# MEMORANDUM

<b>Project:</b>	Spring Creek North Continuation Project Final Void Hydrology Assessment	<b>Date:</b>	6 October 2023
<b>To:</b>	Rolleston Open Cut	<b>From:</b>	Syed Ali, Aaron Baldwin
<b>ATT:</b>	Jeremy Duncan	<b>CC:</b>	Andrew Turnbull, Dave Moss
<b>Subject:</b>	Spring Creek North Continuation Project Final Void Assessment Summary

Figure 4: SCNCP Final Void Lake Levels

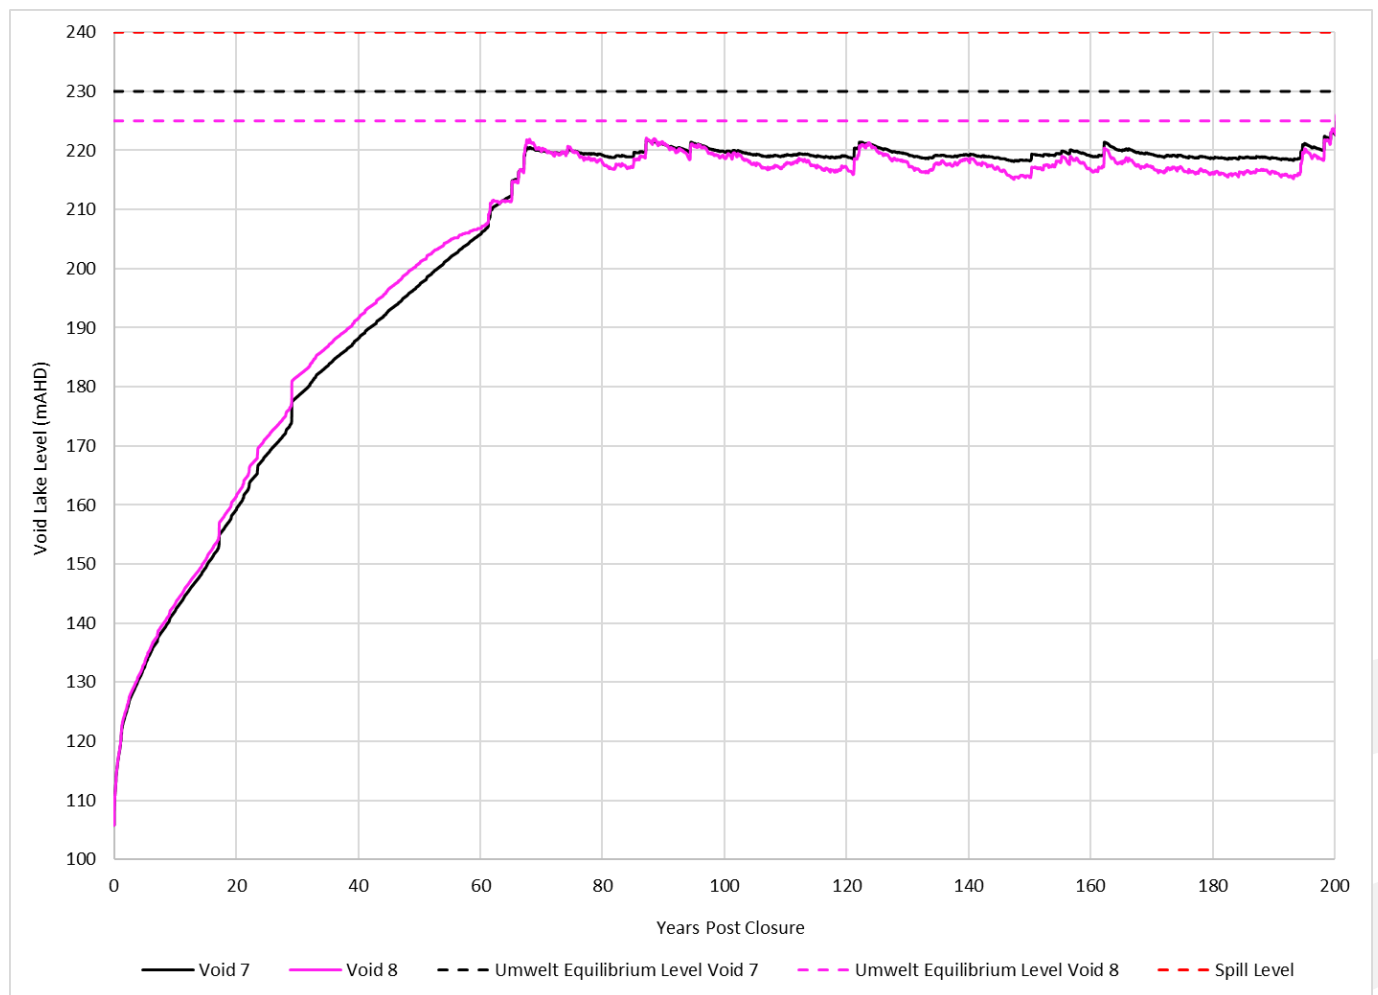
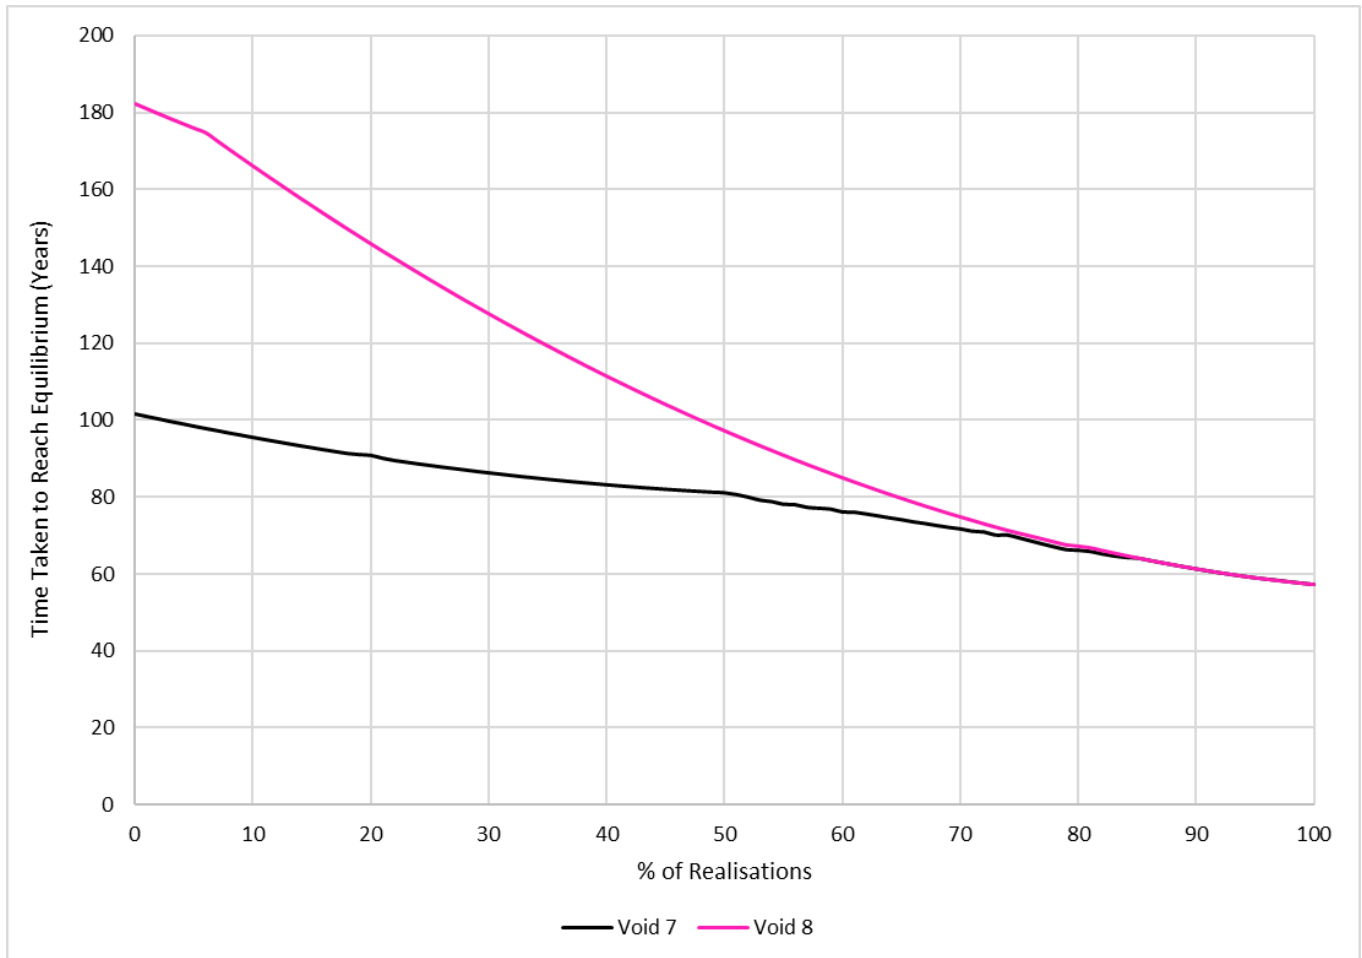
DES Query	Engeny Response Approach	Relevant Section
a) Appendix B, Section 5.5.1 states: "Recharge to the final voids was increased to 150% of annual rainfall to account for overland flow plus surface water diversion." However, it's unclear what surface water assessment was utilised to investigate and assess catchment size and run off to support the assumptions made.	<ul style="list-style-type: none"> <li>Review of the SCNCP final void configuration to determine the final drainage catchment/s.</li> <li>Development of a water balance model to assess the void lake recovery and equilibrium status.</li> <li>Validation of the assumption relating to final void recharge against the predicted void lake level results.</li> </ul>	Results and Discussion, DES Query A

The void lake water balance model results for pit lake water level post mining are shown in Figure 4 and Figure 5 and indicate the following:

- The void lake equilibrium level in Void 7 is 220mAHD and 218mAHD in Void 8
- Following recovery of the pit lake level to equilibrium conditions the void lake level in Void 7 fluctuates between 218mAHD and 221mAHD and between 215mAHD and 224mAHD in Void 8.
- The void lake equilibrium level in Void 8 is lower (~2-3m) than in Void 7.
- Void 7 and Void 8 remain below the equilibrium levels determined in the groundwater assessment indicating the voids will perform as groundwater sinks.
- Under 95<sup>th</sup> percentile wet conditions, Void 7 and Void 8 will reach equilibrium at a similar rate.
- Under median climate conditions, equilibrium will be reached in approximately 80 years in Void 7 and 96 years in Void 8.

- The base case equilibrium levels determined from the groundwater model in Void 7 (230mAHD ) and Void 8 (225mAHD) were similar to those determined in this assessment (220mAHD and 218mAHD, for Void 7 and Void 8, respectively).

- The consistency between the water balance assessment results and the groundwater assessment results suggests the 150% factor applied to rainfall on the pit lake surface area to represent surface runoff in the groundwater model is valid.
